PROJECT REVIEW

1. CASE 23.027, 40 STIMSON AVENUE, Edward S. Clark House, 1892 (STIMSON)

Arrow indicates 40 Stimson Avenue.

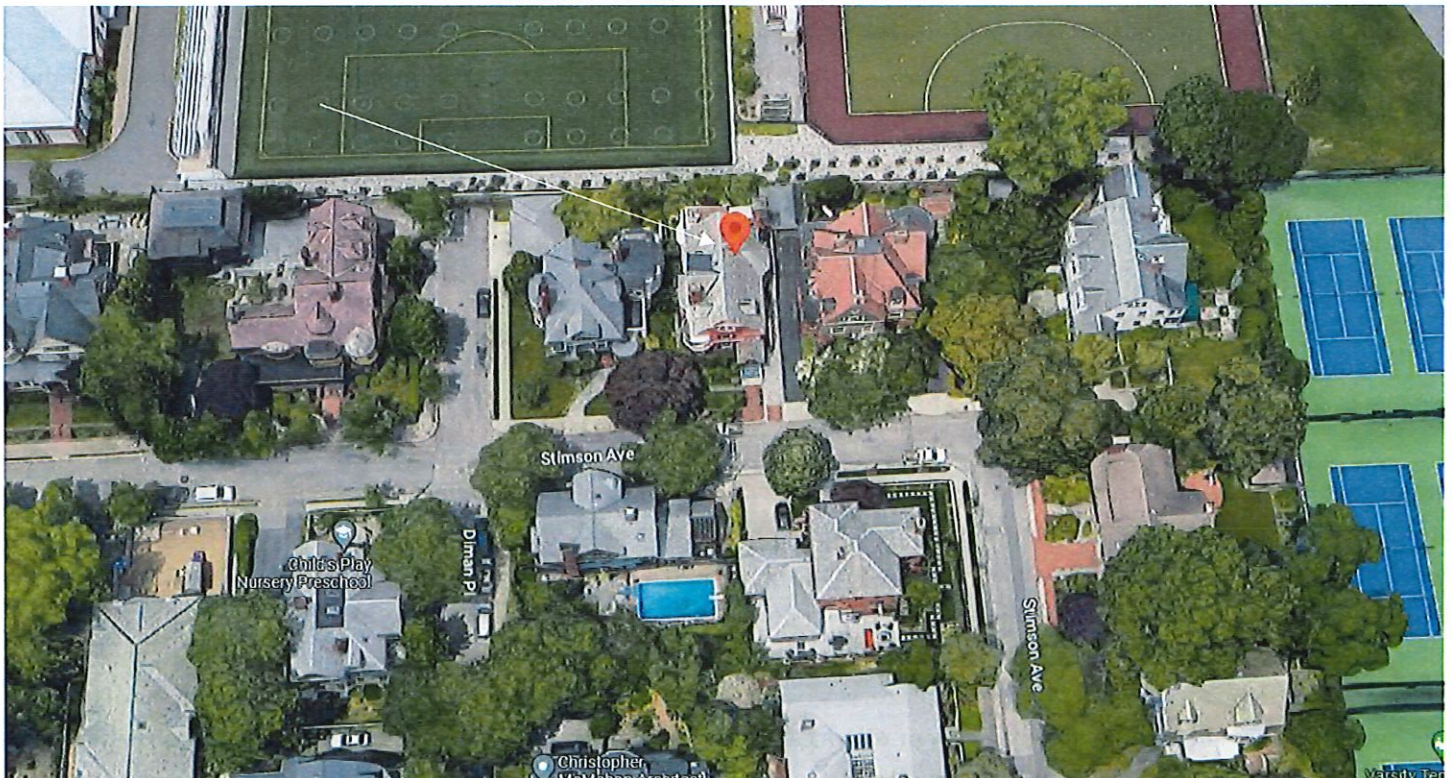
- The applicant contacted staff about the need to replace the slate roof. Staff directed the applicant to have a slate roof specialist evaluate the roof. The applicant had Todd Dumas conduct a site visit and evaluate the roof. Mr. Dumas has provided an email with pictures verifying that the roof is a Vermont green slate that is now defoliating and is past its usable life cycle. The applicant has submitted a quote for costs of replacement asphalt-shingle roof with two options, both Certainteed products: Option 1: Certainteed Pro Architectural \$52,500 and Option 2: Certainteed Grand Manor \$83,250. The Grand Manor is the typical option, but staff would opine that given the visibility of the roof the Architectural Pro shingle may be a viable option. Staff had a conversation with Mr. Dumas about estimate costs for a replacement slate roof and his reply was in excess of \$200,000, potentially up to \$250,000;

- The proposed modifications will be partially visible from the public rights-of-ways. However, due to the orientation of the house and roof form the overall effect on the property and district will be minimal. The most prominent feature is the front entry hood. If the slate roof on the porch could be retained that would further minimize the overall effect; and,

Recommendations: The staff recommends the PHDC make the following findings of fact:
